We are seeking to amend the material stated within our existing approved application (211565). Detail shown below with a description.

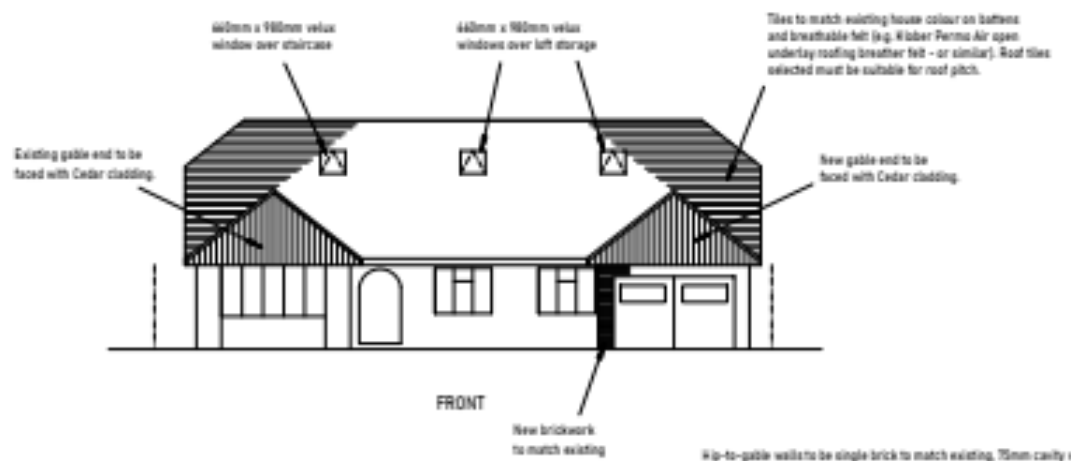
Our original intention was to replace it with Timber Cladding (Cedar) as we'd seen on a few properties locally. See below taken from Architectural Drawings submitted and approved as part of planning application 211565.

See "Existing gable end to be finished in Cedar Cladding" on left hand side of below

What we've since realised is the weathering is not good, leaving it looking very dull and requiring significant "up-keep". The below image is just one example property nearby.

Instead we would look to install "Hardie Plank" as a longer lasting more durable cladding solution. This could be cleaned alongside our windows and fascia/soffits.
